City of Detroit  
Inter-Departmental Communication

**RE:** Petition No. 1201  
Request for Conversion to Easement of a Portion of the East/West Alley in the  
Block Bound by Edinborough, Seven Mile, Huntington, and Clarita

B						REQUEST TO CONVERT TO EASEMENT A PORTION OF THE EAST/WEST PUBLIC ALLEY, 18 FT. WD. IN THE BLOCK BOUND BY EDINBOROUGH, SEVEN MILE W., HUNTINGTON RD. AND CLARITA AVE.	CITY OF DETROIT CITY ENGINEERING DEPARTMENT SURVEY BUREAU
A							
DESCRIPTION		DRWN	CHKD	APPD	DATE		
DRAWN BY		CHECKED					
DATE		APPROVED					
07-06-16							JOB NO. 01-01 DRWG. NO. X 1201

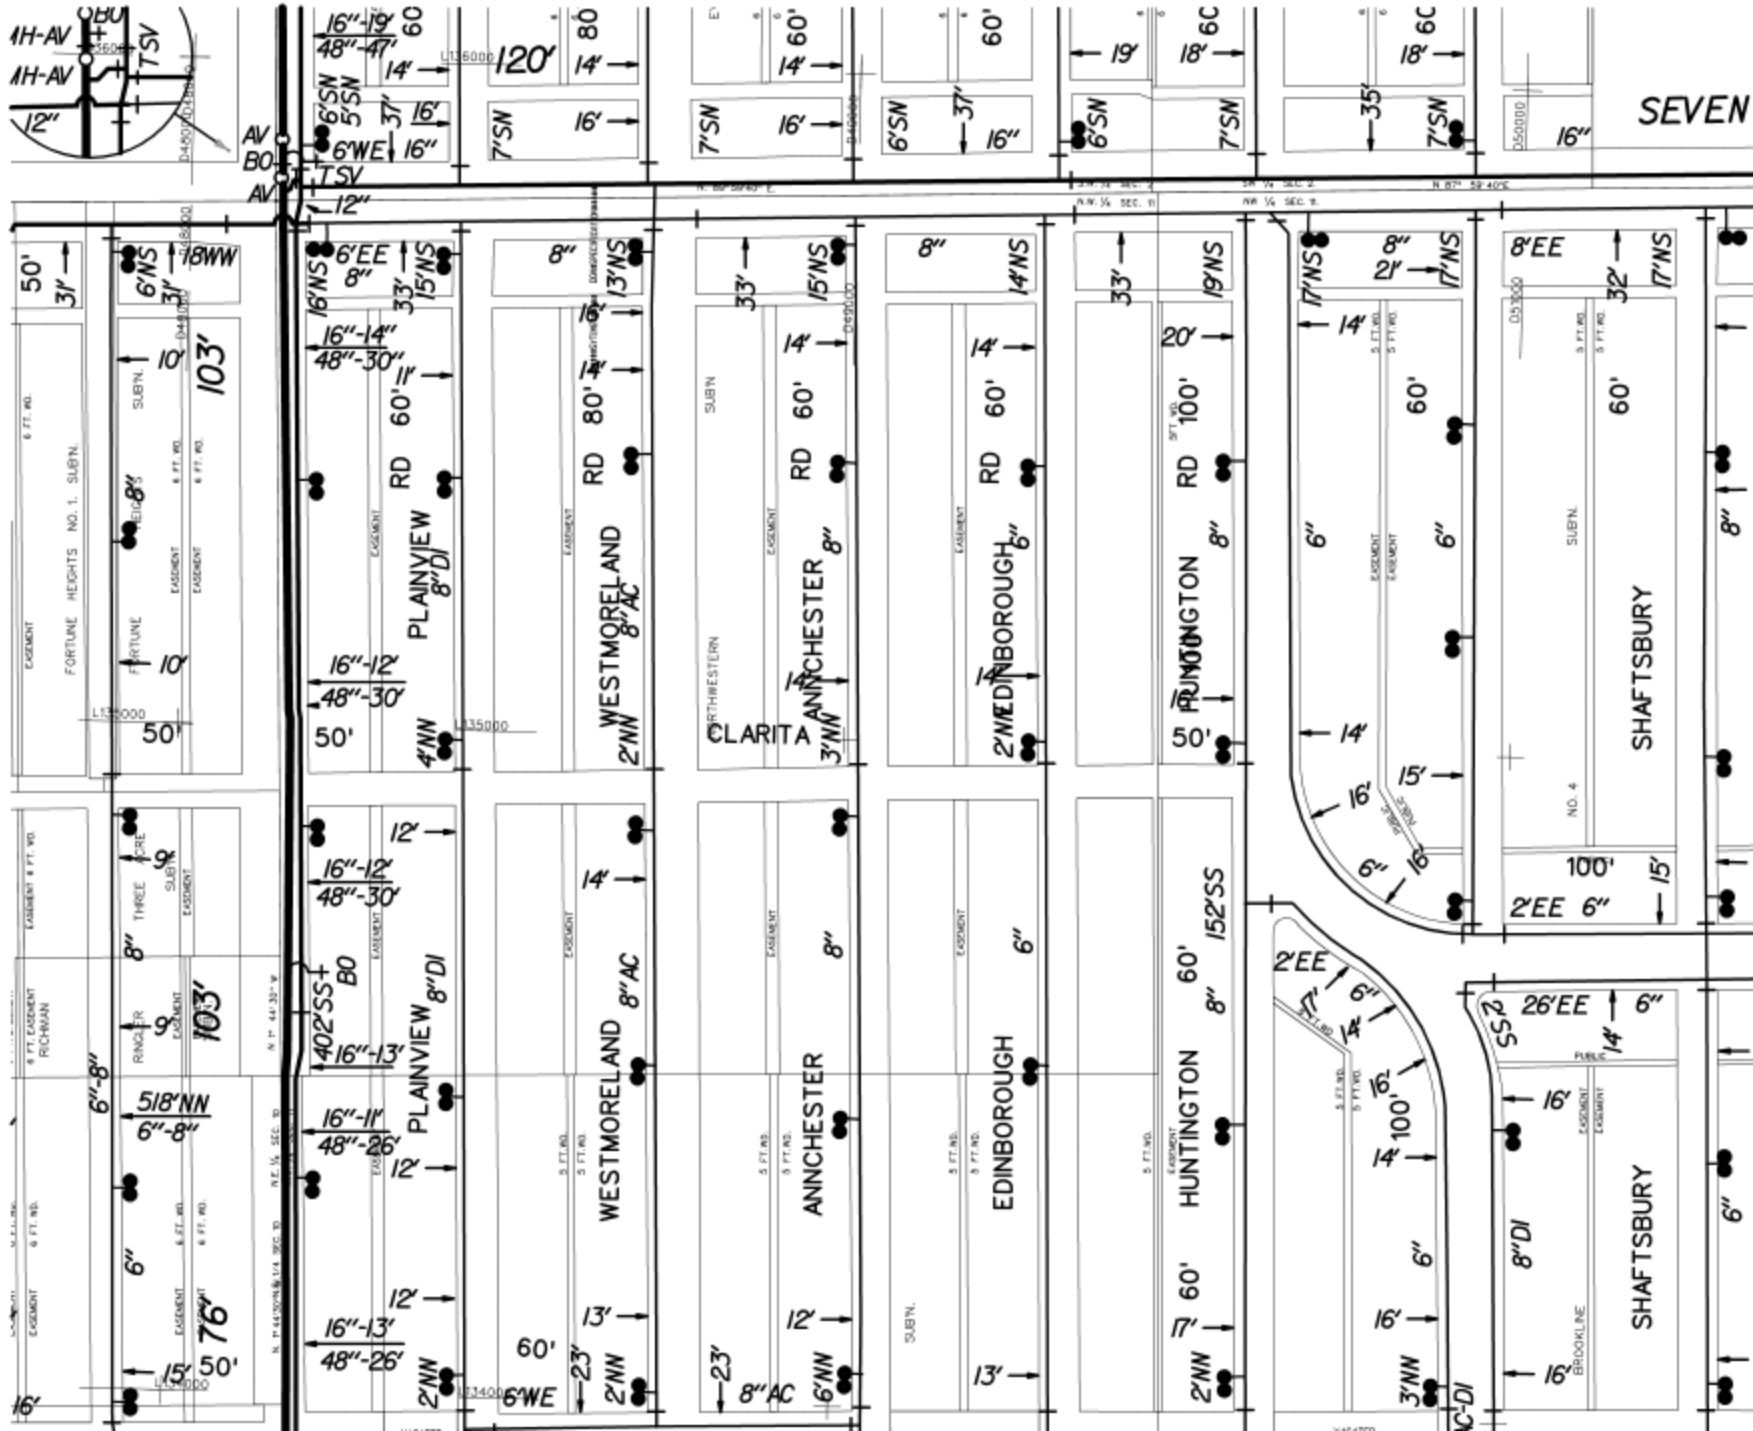
- Our records indicate that there is a sewer in the area of conversion to easement. DWSD has no objection to the requested conversion to easement provided that the attached Provisions for Conversion to Easement are strictly followed.

1. An easement, the full width of the existing right of way, is reserved for the Detroit Water and Sewerage Department for the purpose of installing, maintaining, repairing, removing, or replacing any sewers, water mains, fire hydrants and appurtenances, with the right of ingress and egress at any time to, and over said easement for the purpose above set forth.

Free and easy access to the sewers, water mains, fire hydrants and appurtenances within the easement is required for Detroit Water and Sewerage Department equipment, including the use of backhoes, bull dozers, cranes or pipe trucks, and other heavy construction equipment, as necessary for the alteration or repair of the sewer or water main facilities.

The Detroit Water and Sewerage Department retains the right to install suitable permanent main location guide posts over its water mains at reasonable intervals and at points of deflection.

2. Said owners of the adjoining property, for themselves, their heirs and assigns, agree that no building or structure of any nature whatsoever, including fences, porches, patios, balconies, etc., shall be built upon or over said easement, or that no grade changes or storage of materials shall be made within said easement without prior written approval and agreement with the Detroit Water and Sewerage Department.

3. If at any time in the future, the owners of any lots abutting on said vacated right of way shall request the removal and/or relocation of the aforementioned utilities in said easement, such owners shall pay all costs incident to such removal and/or relocation. It is further provided that if sewers, water mains, and/or appurtenances in said easement shall break or be damaged as a result of any action on the part of the owner, or assigns, then in such event, the owner or assigns shall be liable for all costs incident to the repair of such broken or damaged sewers and water mains, and shall also be liable for all claims for damages resulting from his action.
